## UN R129 – Corrective proposals

Dr. R. Nett, March 2015

## UN R129 – Annex 18

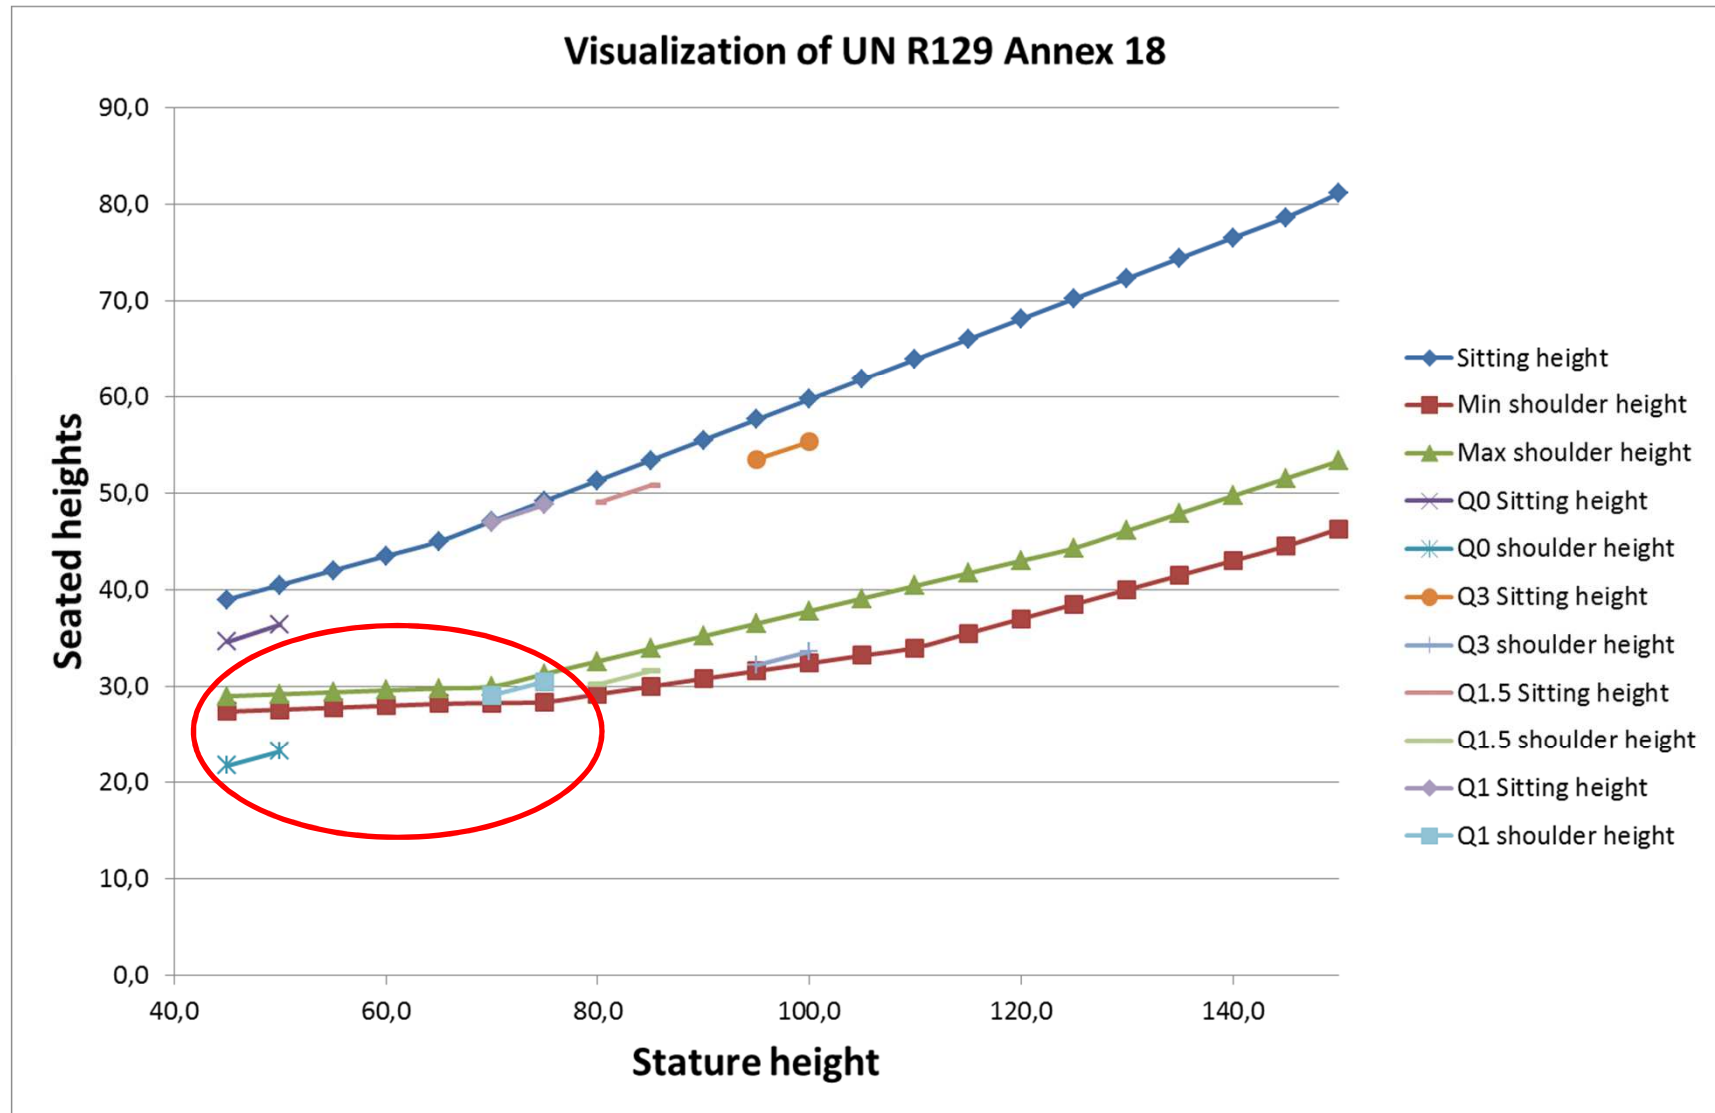
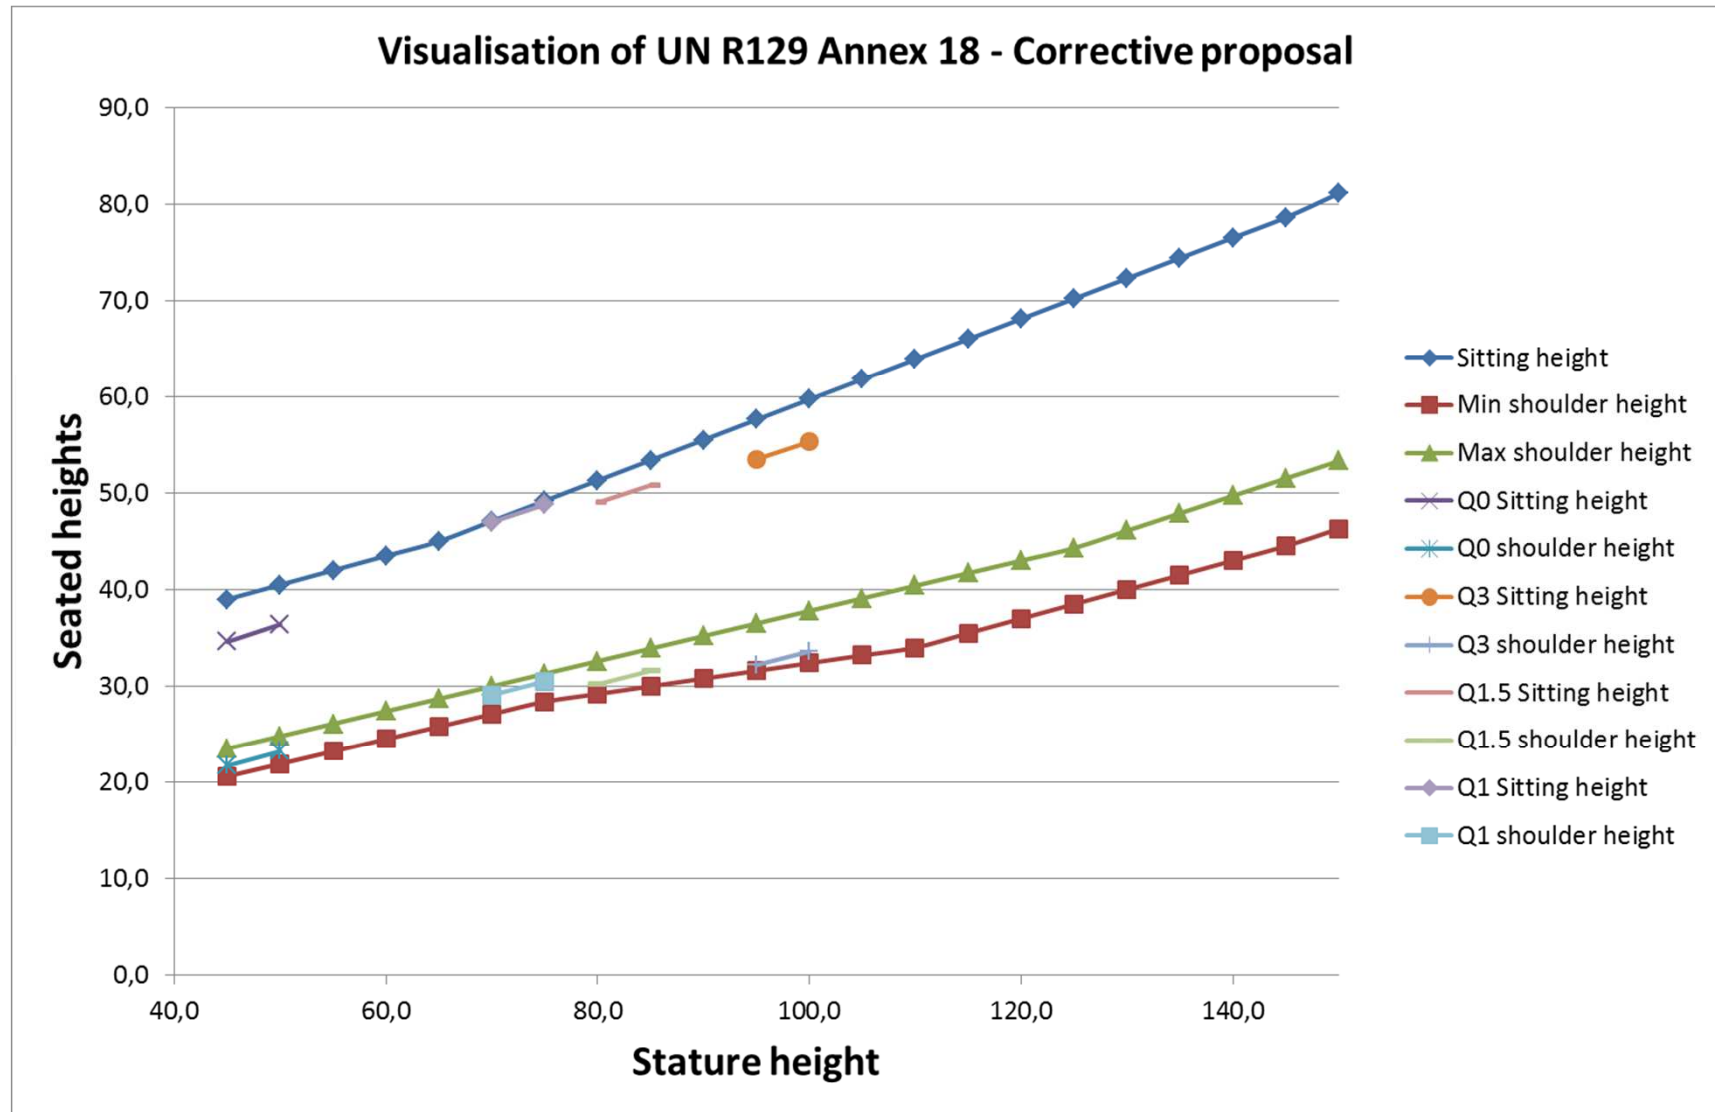
- Shoulder height dimensions (5% & 95%) do not correspond to:
  - current ECE R44 Infant seat harness adjustment devices
  - Q0-dummy dimensions
- Given shoulder height dimensions would not require **any** harness adjustment device for Infants, though the growth rate is at maximum level for Newborn babies
- Example:

A new I-size Infant Seat product (45-75cm) requires a slot range of 4cm only!

**Note:** No detailed instructions are given how to use the measuring device (Annex 18).
